**SIERRA
CLUB**

March 4, 2016

Re: IRRC Consideration of Regulation #7-485: Additional RACT Requirements for Major Sources of NOx and VOCs

*Figure 5: Comparison of Annual Average NOx Emissions in Tons per Year from Pennsylvania's Eight Largest Coal Plants, with SCR-Based RACT Limits, Actual Historical Emissions, and Pennsylvania's RACT Proposed Rule Emission Limits*³⁸

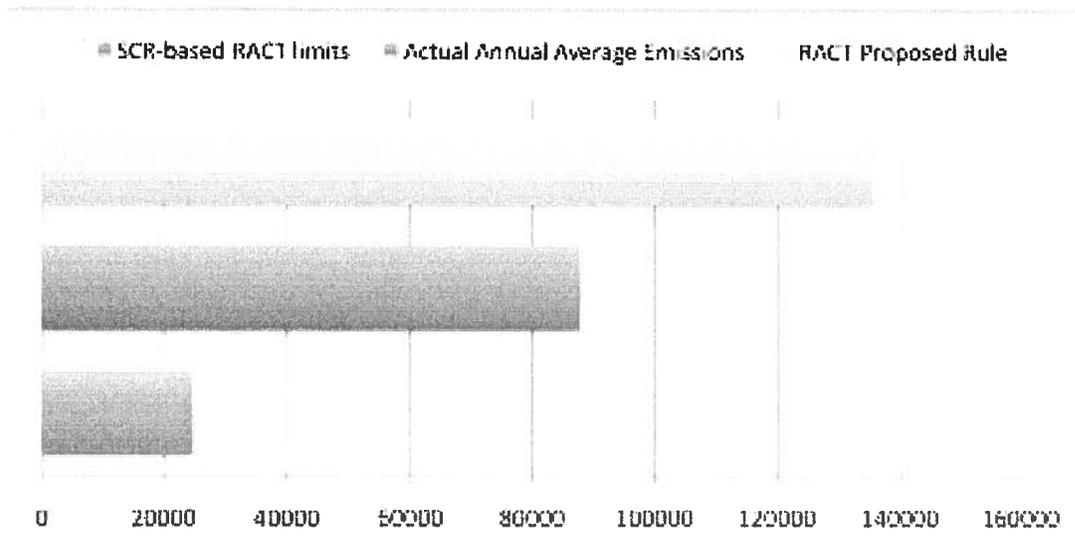
This effect is readily apparent when comparing the aggregate emissions that the eight largest coal plants in Pennsylvania would generate if limited appropriately consistent with SCR operation, with actual emissions, and emissions consistent with Pennsylvania's proposed RACT standard, based on recent capacity factor data.

If the eight largest coal plants in Pennsylvania were required to abide by RACT limits consistent with SCR operation, they would (based on historical levels of operation) emit less than 25,000 tons of NOx per year; by comparison, these facilities have averaged emissions of nearly 88,000 tons per year, and would emit nearly 136,000 tons per year under the limits DEP's RACT Proposed Rule (again, based on historical levels of plant operation).³⁹

Figure 1: NOx from Stationary Sources in Southeastern Pennsylvania Counties

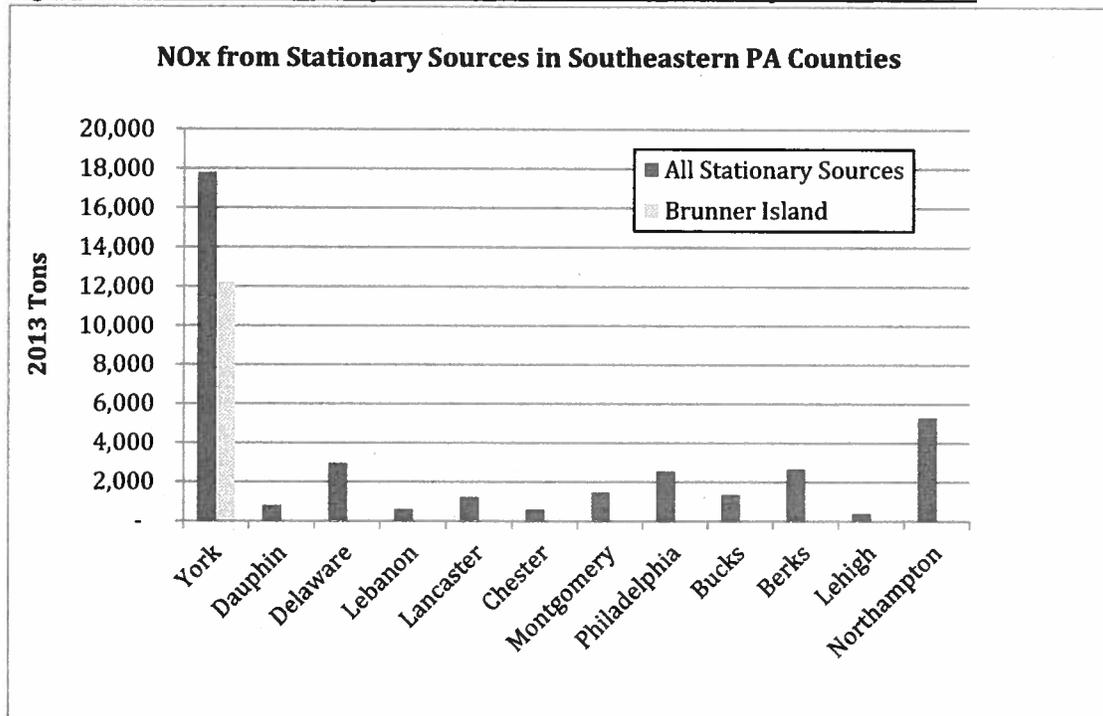
Accordingly, and as demonstrated in Figure 1, Brunner Island is by far the largest stationary source of NOx pollution in Southeast Pennsylvania.

Notably, Figure 1 lists emissions in 2013. Under the current RACT proposal, other stationary sources would be reducing their NOx emissions, while Brunner Island's would remain essentially unchanged.⁵

Figure 1: Historical Brunner Island Plantwide NOx Emissions (tons per year)¹

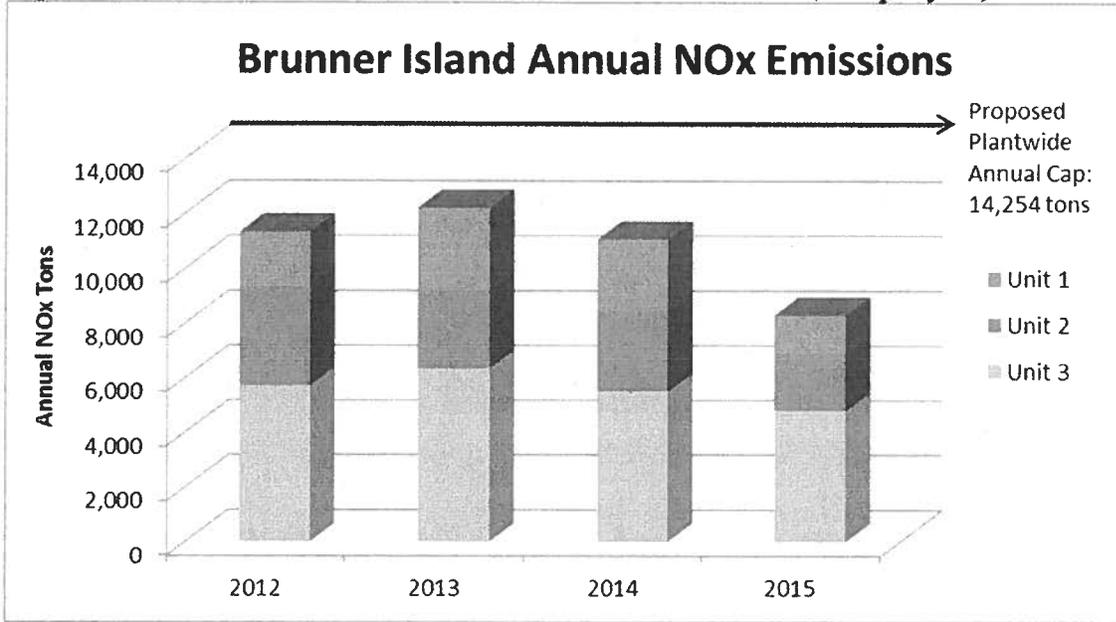
However, these limits are greatly in excess of actual emissions from Brunner Island, as Figure 1 demonstrates:

The proposed emission limits thus would do really nothing to actually constrain emissions from Brunner Island at all. This is plain when viewing even historical twelve-month rolling emissions from the facility:

Figure 2: Rolling Historical Brunner Island Plantwide NOx Emissions (tons per year)²

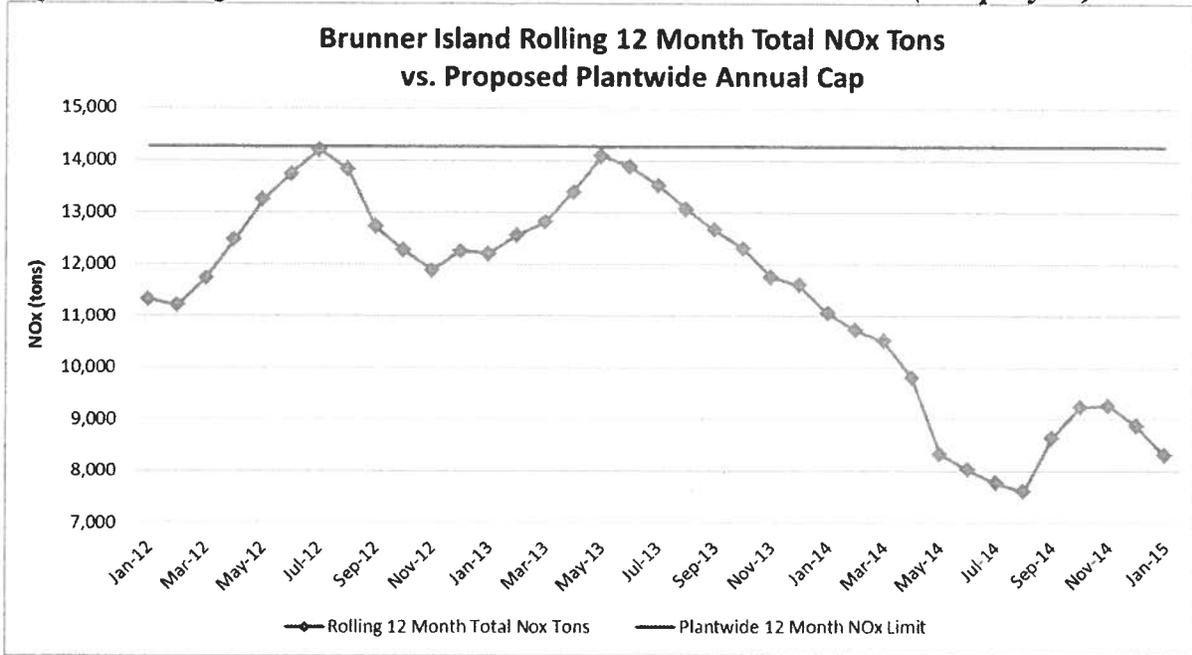
The proposed plan approval’s plantwide emission limit would thus fail to appreciably (or at all) drive reductions in actual emissions of pollutants from Brunner Island.

Figure 3: Historical Brunner Island Units 1-3 NOx Emissions (tons per year)³

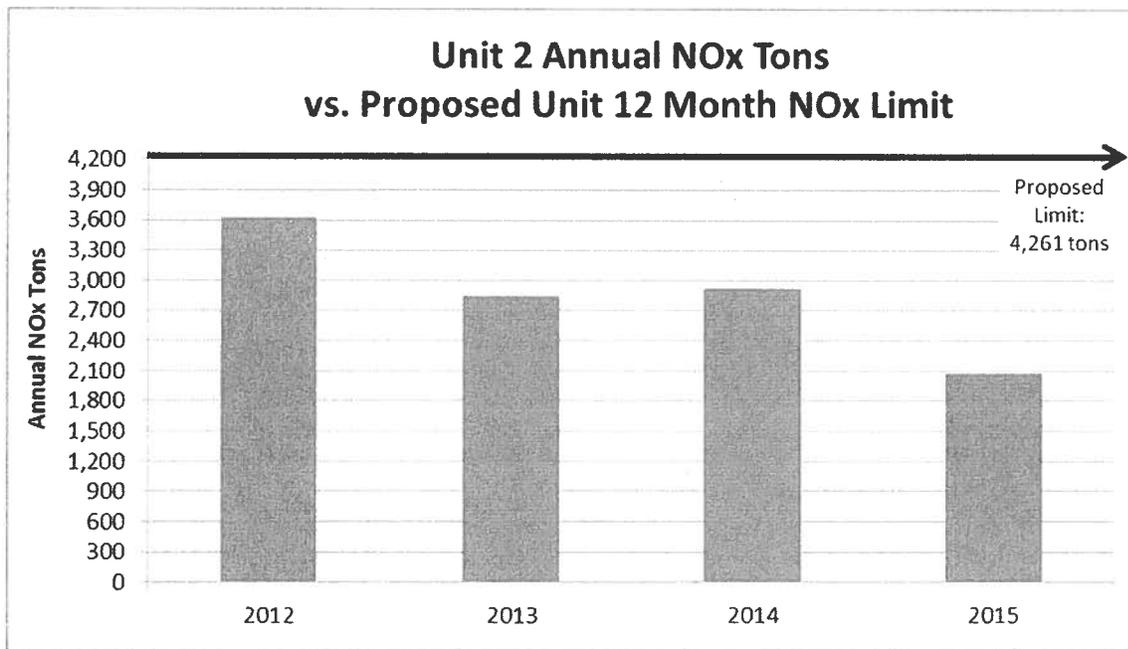
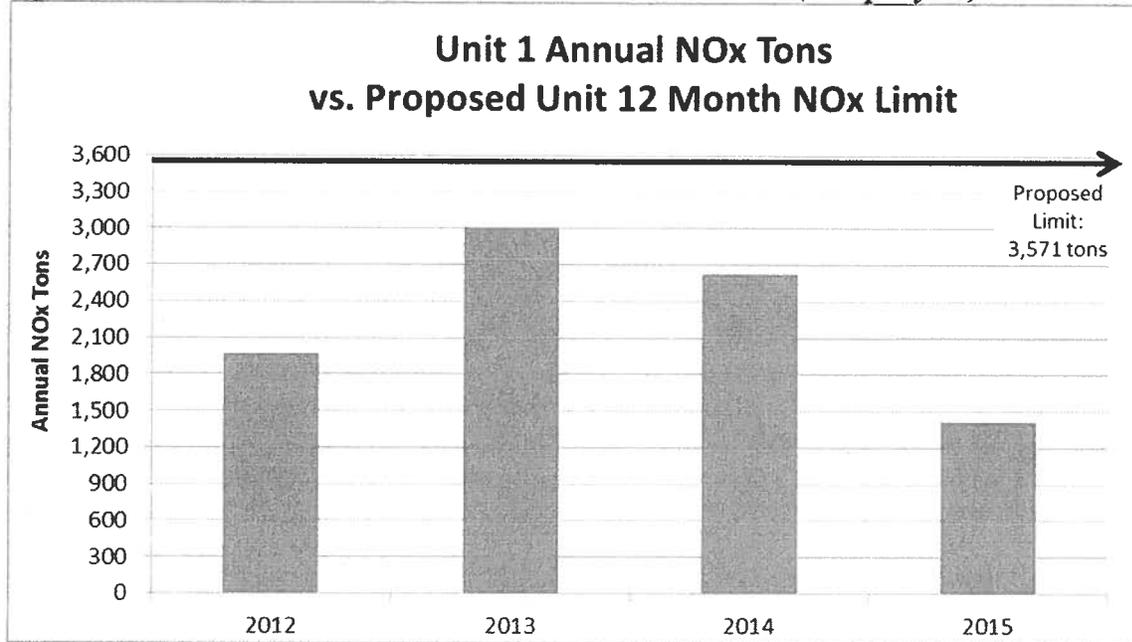
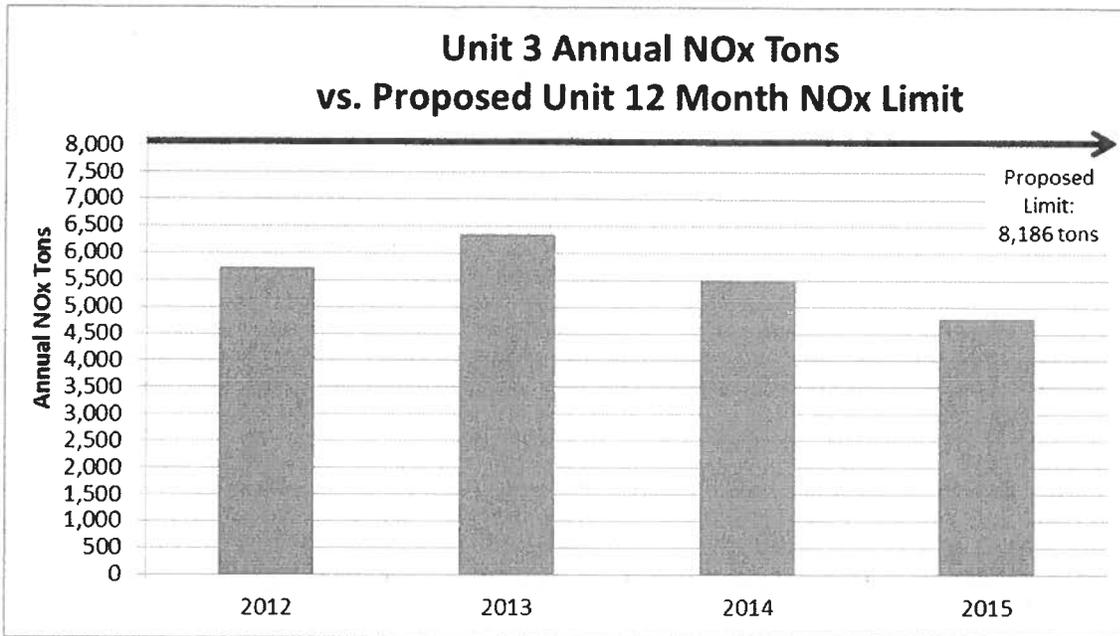
The contemplated limits for the individual units (which collectively sum to 16,198 tons per year, or nearly two thousand tons more than the plantwide limit) likewise would not impact Brunner Island’s actual emissions, as demonstrated from historical emissions data:

This failure of the proposed emission limits to actually limit emissions is all the more stark in face of the fact that DEP has approved installation of gas-burning capability at Brunner Island.⁴ Gas combustion at EGUs results in greatly decreased NOx emissions versus coal-firing. Indeed, Brunner Island could readily decrease its NOx emissions at low cost—likely even *negative* cost, given current and projected coal and gas prices⁵—and yet the contemplated plan approval ignores this to “cap” annual emissions at levels higher than what the facility actually emits.

Figure 4: Brunner Island Historical NOx Emissions and Emissions with Calculated RACT- and SCR-Consistent Emission Rates¹⁹

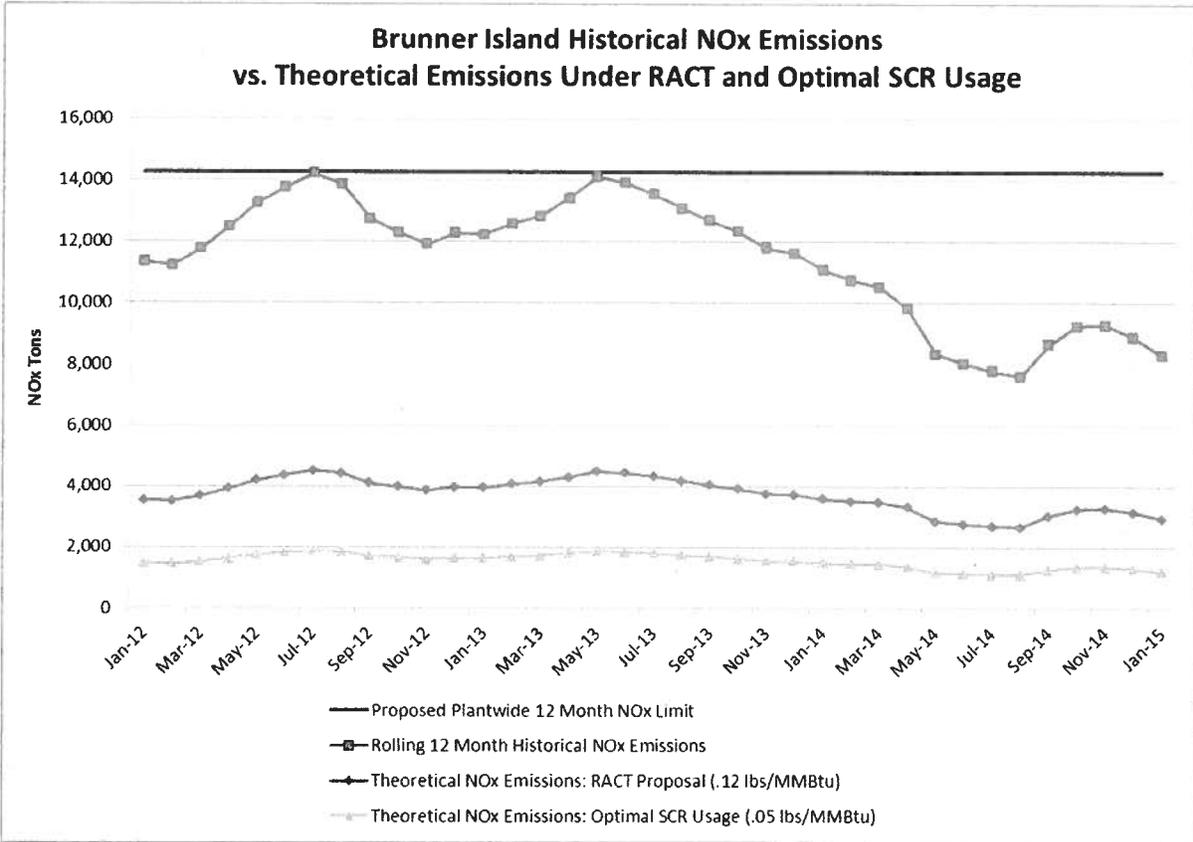
require Brunner Island to actually decrease its emissions, as the annual limits are set significantly above the facility's historical emission levels. As Figure 4 below makes clear, the result is that Brunner Island would, even under the proposed plan approval, be allowed to emit vastly more NOx than it would if it were required to abide by the same emission limits every other large coal unit in Pennsylvania would comply with under the RACT proposal.

Under the proposed plan approval, Brunner Island would be permitted to emit some 10,000 tons more NOx per year than would be emitted if Brunner Island were required to achieve the 0.12 lbs/MMBtu emission rate applicable to SCR-equipped units under the RACT proposal (based on historical Brunner Island heat outputs). But even this vast gulf understates the situation: SCR-equipped units can readily achieve far better emission rates, as low as 0.05 lbs/MMBtu or lower.
